UNITED STATES PATENT AND TRADEMARK OFFICE

APPLICATION NO.	FILING DATE	FIRST NAMED INVENTOR	ATTORNEY DOCKET NO.	CONFIRMATION NO.
10/642,828	08/19/2003	Huan-Jan Chien	BHT-3111-353	3818

Office Action Summary

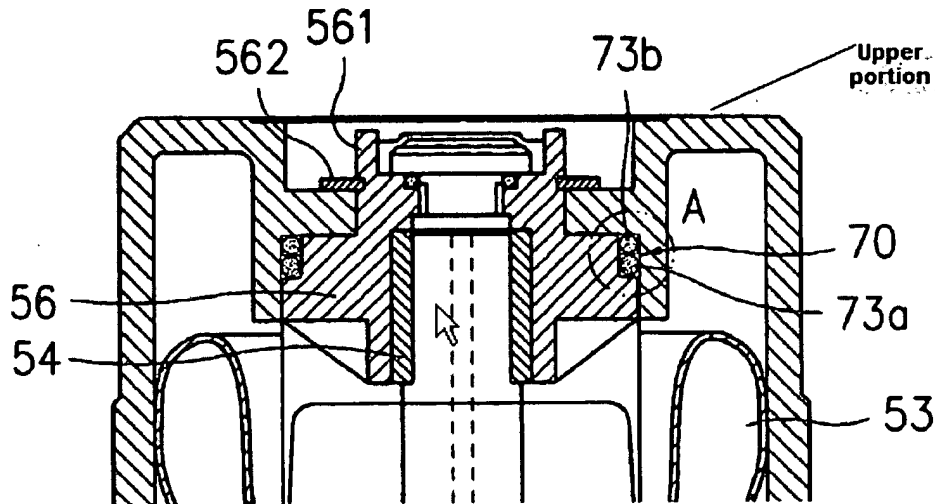
Claim 13, the applicant's use of "the upper portion" is not accurate with the drawings.

Above figure shows the said upper portion. The language of claim 13 is confusing and needs revision. The applicant is suggested that because of the improper claim language the invention reads on the prior art.

Figure 1

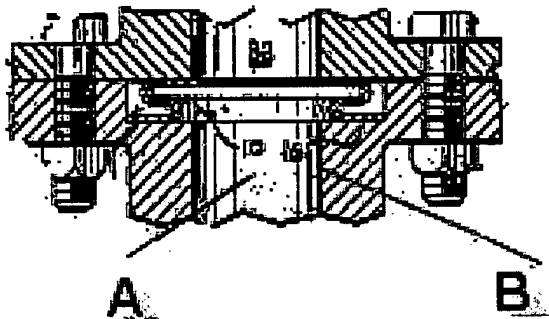
With respect to Claim 2 (Dunkle) show the bending structure of the inner shell located at the upper edge of the inner shell.

A is the inner shell in figure 1.

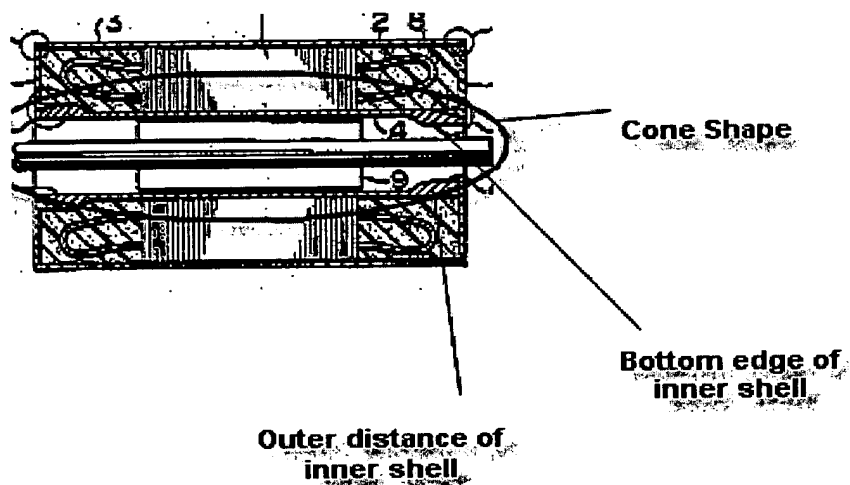
B is the outer surface of the inner shell in figure 1.
